*planning review*

Project: **Torch River RV Park  
Technical Review**

Request Special Land Use

**To:** John Iacoangeli, Beckett & Raeder  
**From:** Barr Engineering Co. (Barr)  
**Subject:** Torch River RV Park, Milton Township, Antrim County, MI – Technical Review DRAFT  
**Date:** March 9, 2021  
**Project:** 22/05-1005.00

Figure 1.0 RV Site Layout

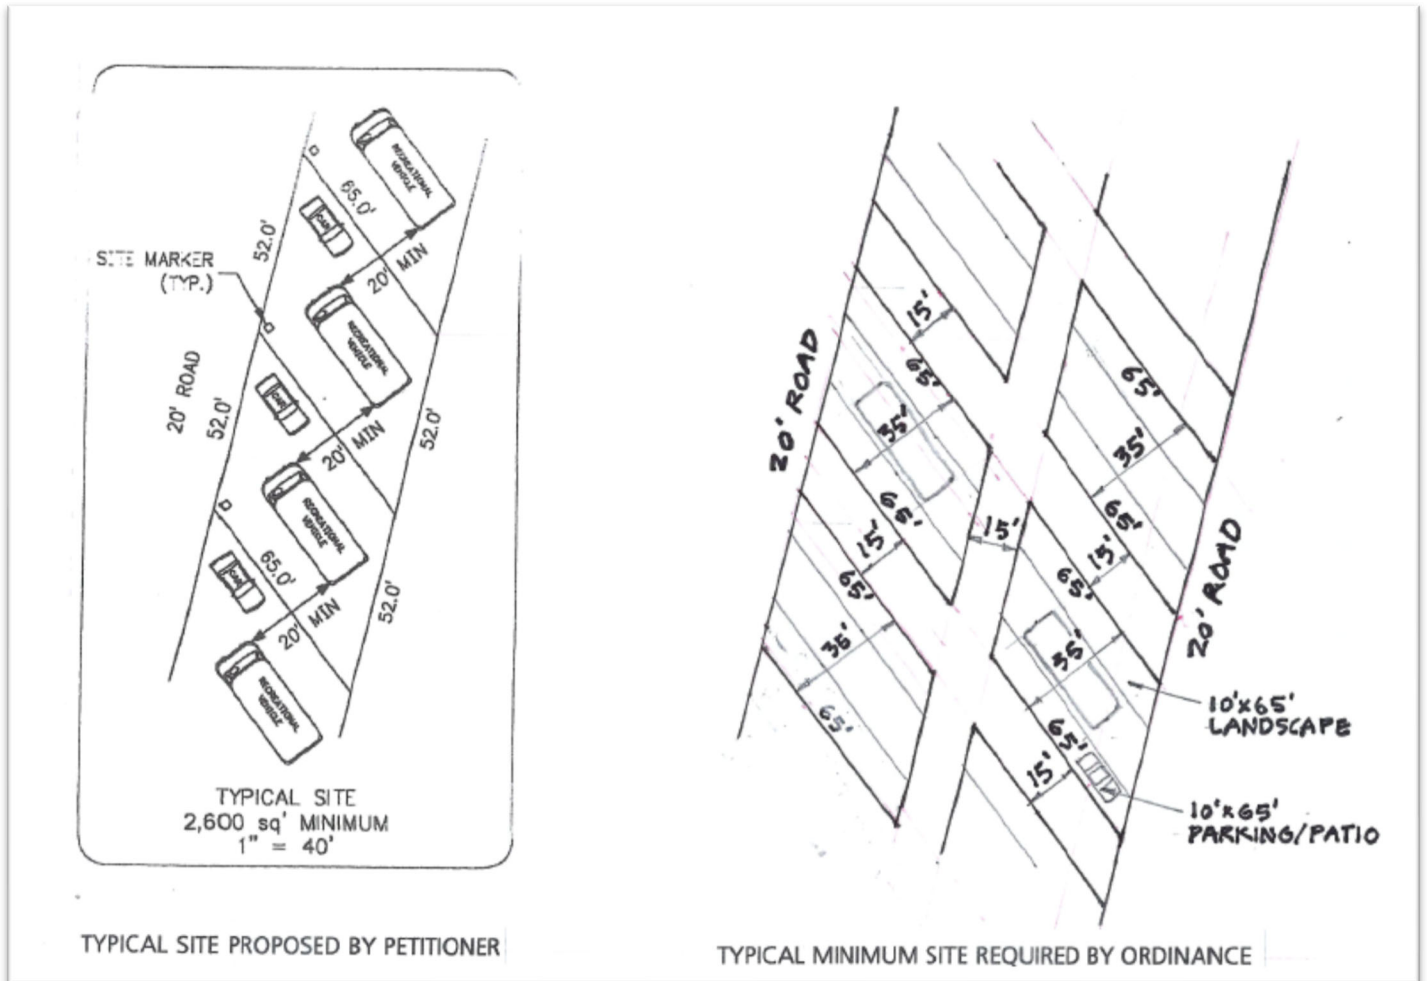
1. The most obvious deficiency noted on the Typical Site Detail and the Site Plan is the absence of the 15' distance between sites as required by Clause D of the Zoning Ordinance, Recreational Vehicle Seasonal Park. Refer to **Figure 1.0** for an illustration of the difference between the proposed Typical Site Detail and application of the Ordinance requirements to a typical site. The site plan layout will require modification to include the 15' distance between sites even if the size of the sites are reduced to the Ordinance square foot minimum of 2,275 square feet.

2. Neither the Typical Site Detail or the Plan indicate the 10' by 65' strip of landscaping on the driver side of the recreational vehicle or the 10' by 65' parking / patio surface on the passenger side of the recreational vehicle as required by Item C, (1) and (2) of the Zoning Ordinance Recreational Vehicle Seasonal Park. Refer to **Figure 1.0**.
